## MEMORANDUM

**Re:** Cape View Way Civil Engineering/Site Design Peer Review Response

## RESPONSE TO COMMENTS

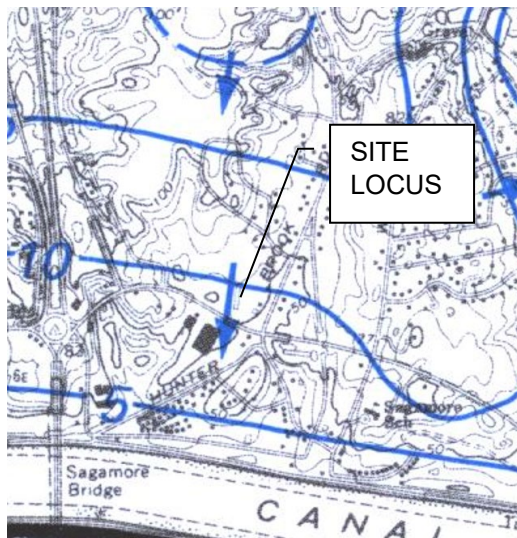
46. *The plan does not provide deep observation holes and percolation tests verifying a suitable location for the reserve area.*

**RESPONSE:** Additional soil testing acceptable to the Bourne Health Department will be provided for the revised leaching system trench design if necessary.

**RESPONSE:** Regional groundwater contour data indicates a groundwater elevation of 10-ft, which is approximately 40-feet below grade at the site. No standing water was observed during soil testing. See image below from plan titled "Altitude of Water Table in Plymouth-Carver Area, Southeastern Massachusetts, November 30 – December 2, 1984 prepared by Bruce Hansen and Wayne Lapham, 1992".

Bourne MA Truck 126 (updated Dec 2020)	
Overall Length	47.250ft
Overall Width	9.000ft
Overall Body Height	11.000ft
Min Body Ground Clearance	0.896ft
Track Width	9.000ft
Lock-to-lock time	5.00s
Curb to Curb Turning Radius	49.000ft

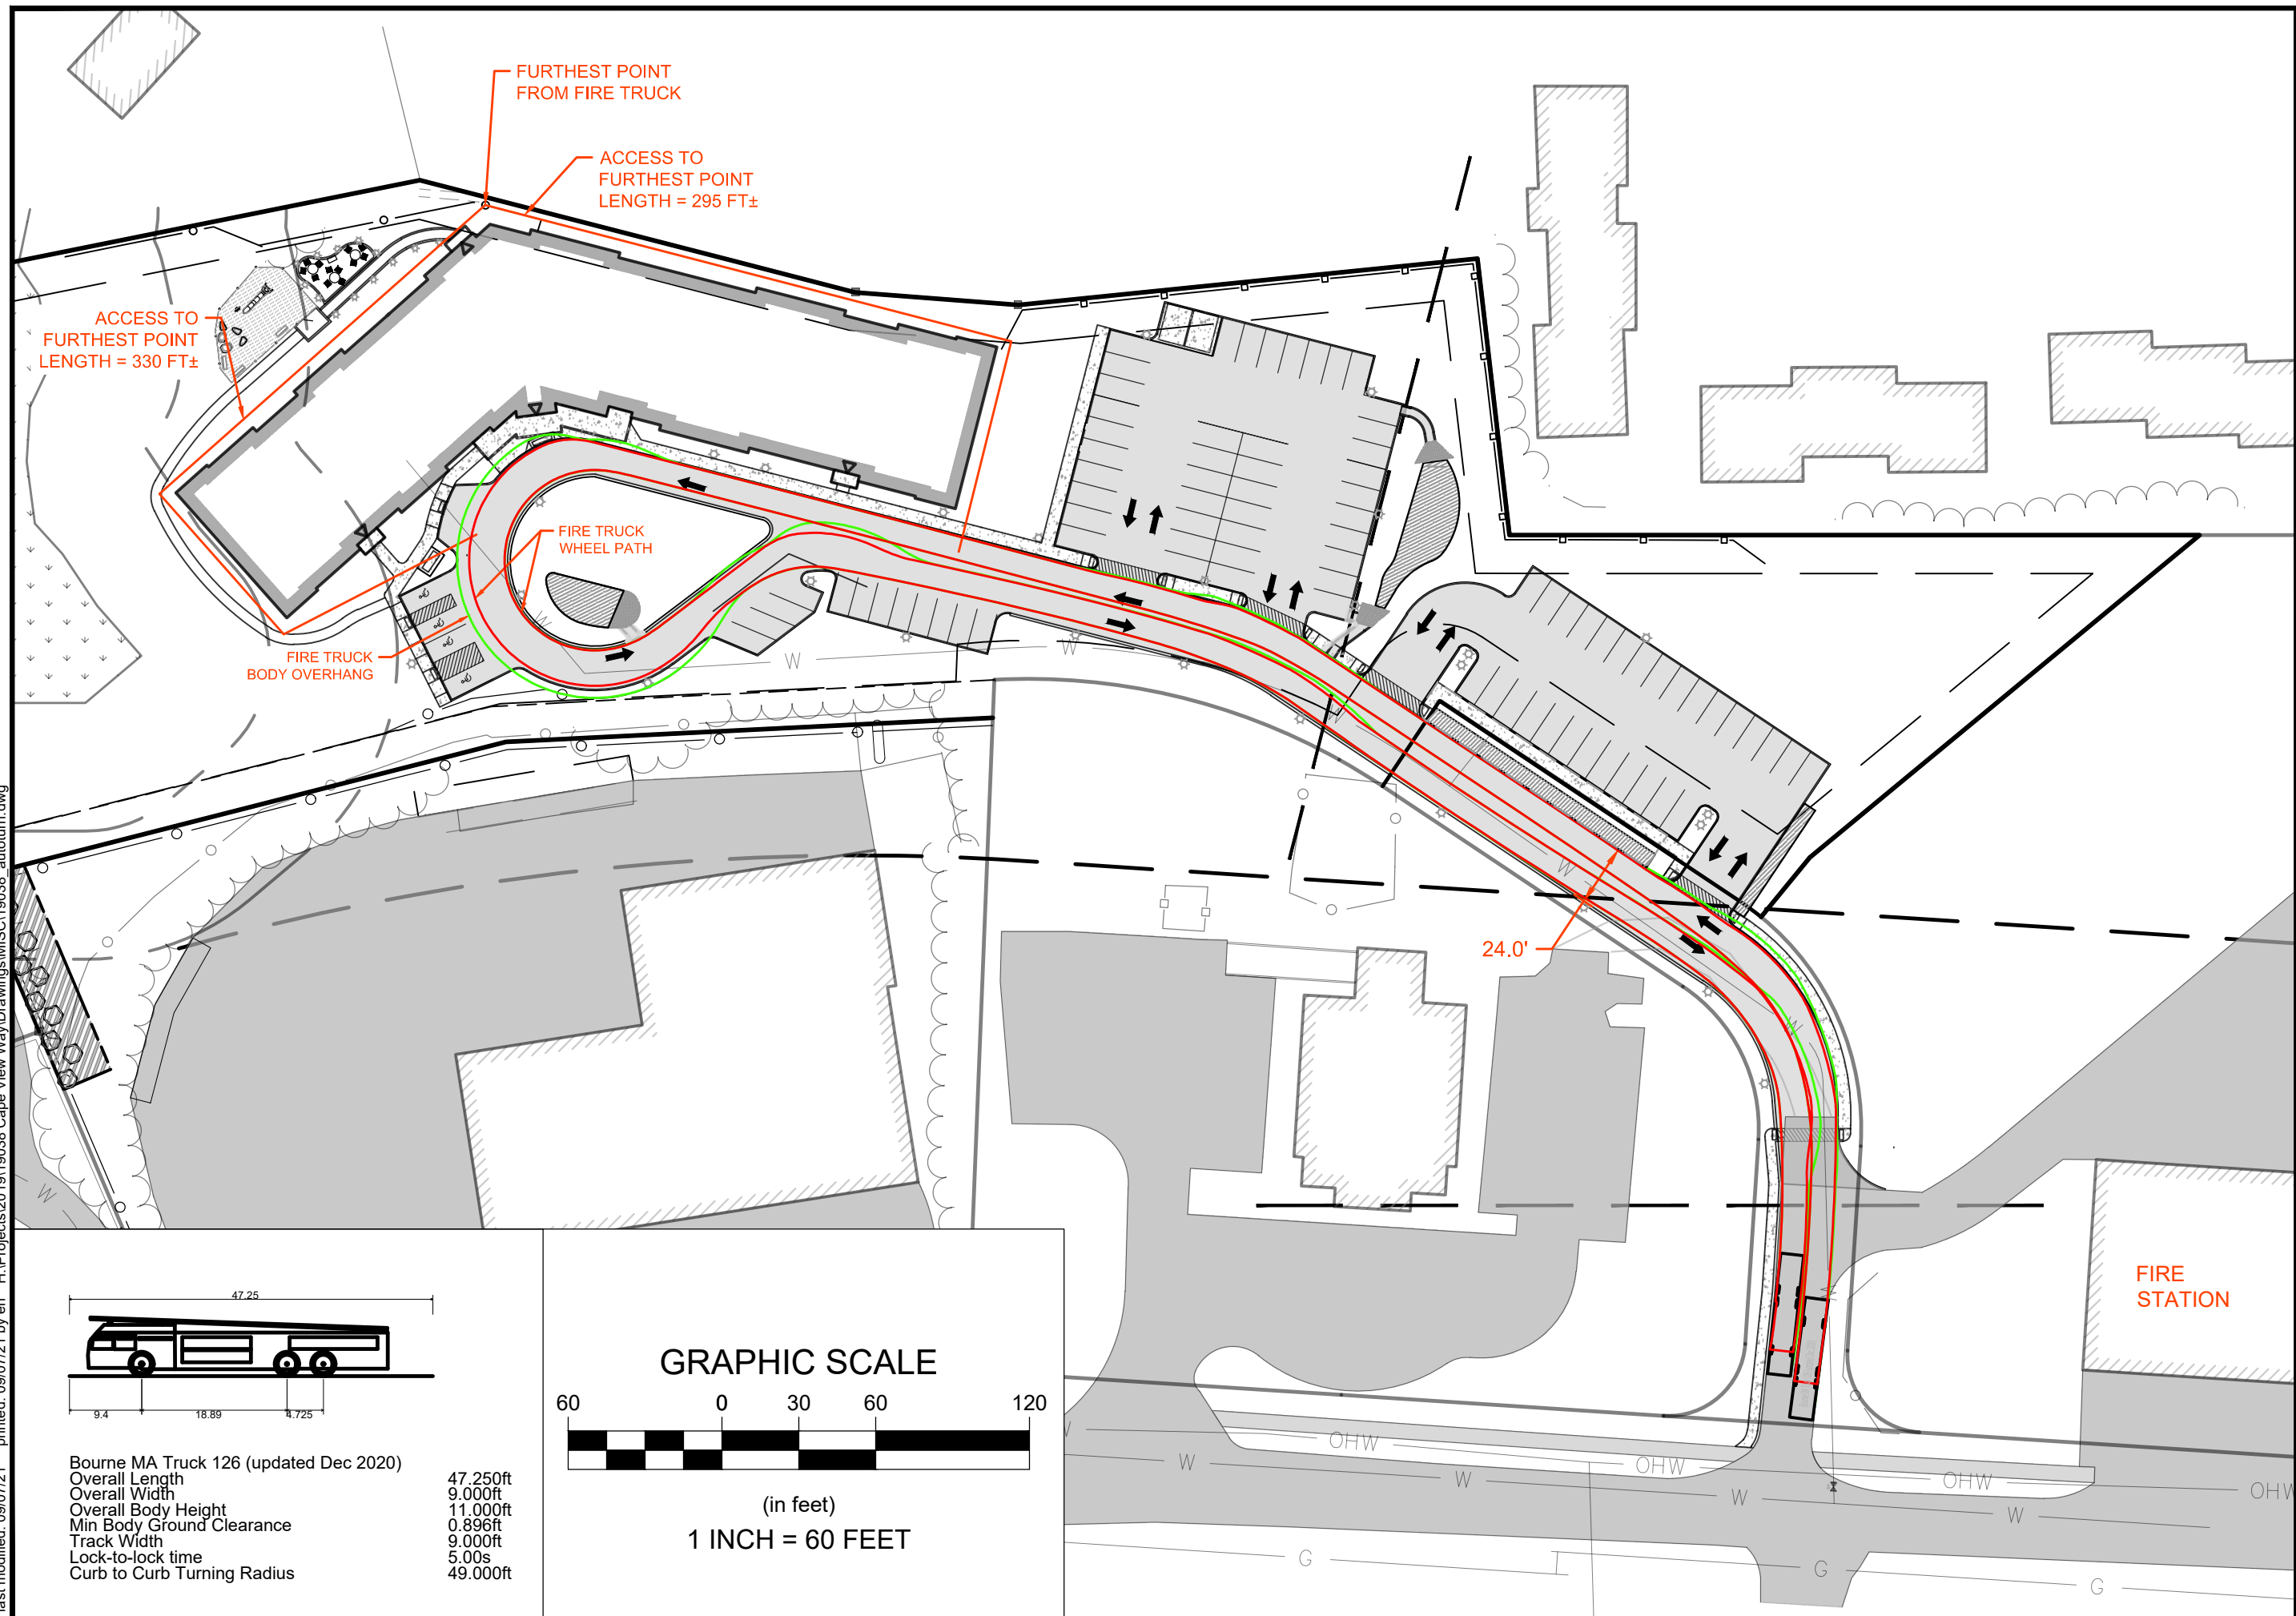
4. *In the drop off area at the main building entrance, revise the cul-de-sac island to accommodate fire apparatus and any large vehicles expected to use the site requires a new subdivision approval or modification.*

- *For the 4 compact perpendicular parking spaces that are accessed from the pavement within the turnaround at the building entrance, provide an overall width of this parking bay (aisle plus parking space) of 42 ft. to ensure proper vehicle maneuvering.*

**RESPONSE:** The Applicant has included the emergency vehicle turning radius template with this memo to show that a fire truck is able to use the turnaround as well as a letter from Assistant Fire Chief Pelonzi regarding fire access at the proposed site.

**RESPONSE:** The emergency vehicle turning radius template has been submitted along with a letter from Assistant Fire Chief Pelonzi to demonstrate the Bourne fire truck dimensions provided is able to use the turnaround.
